SUBJECT: Proposed Popeyes Restaurant with Drive-thru
701 N. 19th Street
LMA-2022-00009

Planning & Zoning Staff Report to the Allentown City Planning Commission January 10, 2023

RE: Allentown PA Development, LLC
Proposed Popeyes Restaurant with Drive-Thru
Final Land Development Plan
Comment Response Letter #2
701 North 19th Street and Tilghman Street
City of Allentown, Lehigh County, PA
SDC #897.10

FINAL LAND DEVELOPMENT PLAN PROPOSED RESTAURANT WITH DRIVE-THRU FOR ALLENTOWN PA DEVELOPMENT, LLC

SITE LAYOUT PLAN

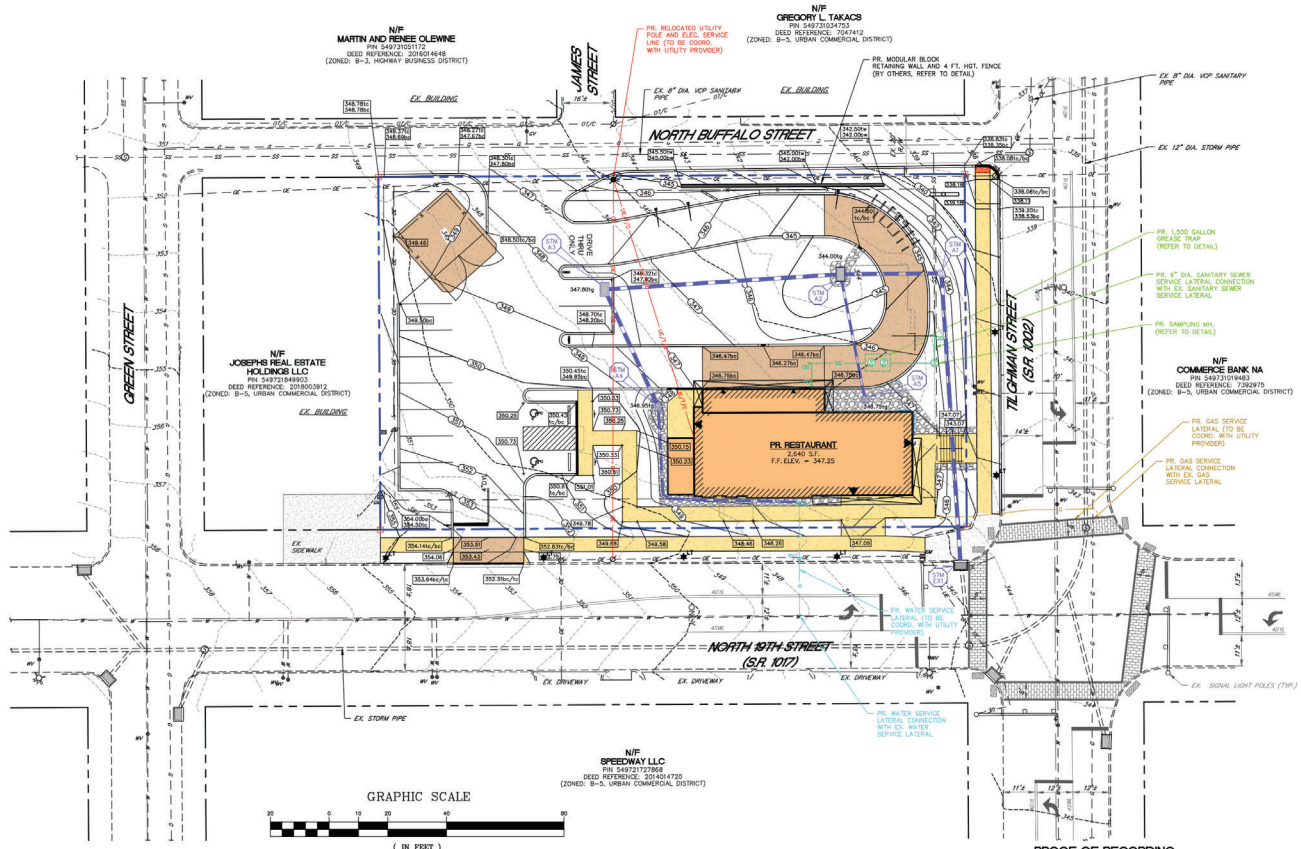
11. Sheet C-4 should show the existing overhead electric line to the billboard. A utility easement should be proposed encompassing the existing overhead electric line.

13. The existing OH Elec. Line has been added as well as the billboard to the plans.
14. We have searched all documents, deeds, etc. for an existing easement width associated with the electric line and have not found any documents referencing an easement width. We believe that it is an assumed blanket easement.

CITY OF ALLENTOWN - CONCRETE CURB AND SIDEWALK SECTION ALONG N. 19TH ST. AND TILGHMAN ST.
NO SCALE

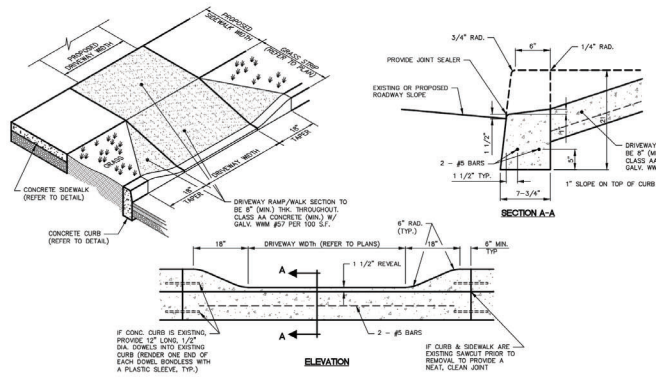
3. Provide approval from LCA for the water and sewer connections.
4. Provide PennDOT approved HOP.
5. The sidewalk cross slope on the City's Sidewalk detail should be 1/4" per foot.

5. Surveyors Certification has been revised to match the SALDO.
6. Details for sidewalk, curb and crossover have been added to the plans Sht. C-8.
7. Detectable warning surfaces have been removed from driveway crossing.

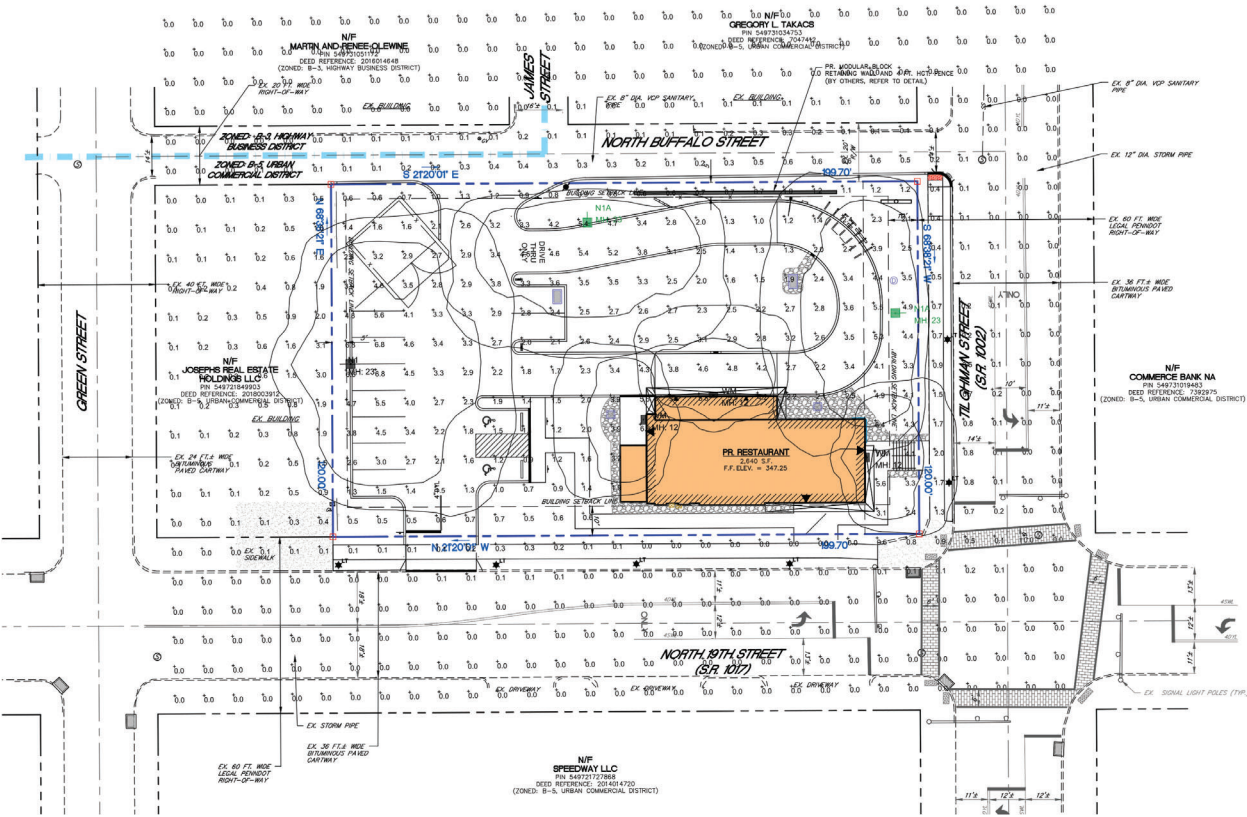
4. Traffic signal revisions and HOP must be approved by the City and PennDOT.
5. Provide three pedestrian style lights on Northside of Tilghman Street. The plan detail for the streetlight is not showing the city standard pedestrian style lighting and 7-pin telecell photocell. Provide city standard pedestrian style light details with a tabulation chart showing the quantity, type, lumens, wattage, etc. for the fixtures.

1. All existing geometry, signals, ramps, signage and pavement markings on N. 19th St. and Tilghman St. have been added to the plans
2. Signal and pedestrian improvements are not required. A PennDOT HOP will be applied for improvements made within the State roadways.
3. Lighting information is shown on Sheet LP-1.
4. Noted.
